Re: Comments on Bosma Lagoon 10 Basis of Design Report  
Administrative Order on Consent ("Consent Order")  
Docket No. SDWA-10-2013-0080  
Yakima Valley Dairies, Washington

H&S Bosma Dairy Consolidated Lagoon No. 10 Basis of Design Report 100% Design Submittal  
(June 24, 2019)

**Figure 3**  
**H&S Bosma Dairy Consolidated Lagoon No. 10 Subsurface Soil Characteristics Cross Section 10A-10A'**

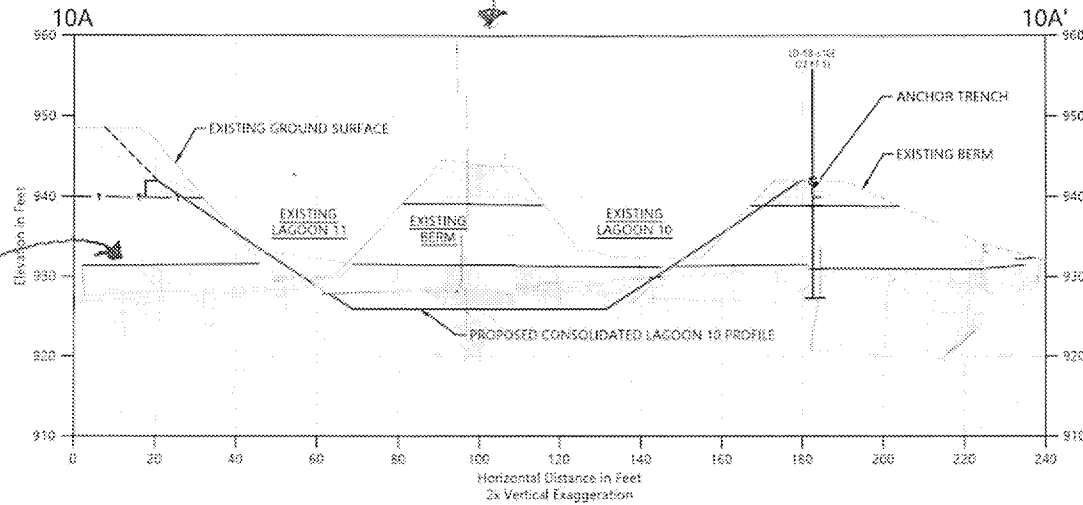
12. Consideration of the test pit data indicates that Figure 3 (H&S Bosma Dairy Consolidated Lagoon No. 10 Subsurface Soil Characteristics Cross Section 10A-10A') in the approved Report is inaccurate. Provide a revised Figure 3 (lagoon cross section) that includes consideration of the test pit data. The test pit sample data indicate that the bottoms of Lagoon 10 and/or Lagoon 11 intersect the lower "Gravelly Silty Sand (Fill)" soil layer shown in Figure 3 in the Report. Delete the information from LD-SB-L105S, which is located 138 feet south of the cross section and is not consistent with the data that is available on the cross section.

Pursuant to Paragraph 14 of the Consent Order, the Respondents must address these comments and re-submit this document no later than August 16, 2019. Revise Figure 3 as indicated in the enclosed figure which EPA has modified.

The geologist's field notes indicate that all three samples contained cobbles, and the laboratory data indicate they contained less than 10% fines. Such soils are difficult to compact, porous, and prone to relatively high rates of leakage. This lagoon leaked significantly when in use. These data indicate that this lagoon and ones like it, such as the group of lagoons upgradient of YVD-08, were<sup>1</sup> significant sources of nitrate to the drinking water aquifer and downgradient residential drinking water wells.

Delete south boring (not on transect)

Raise this line to intersect bottom of Lagoon 11 (as shown)
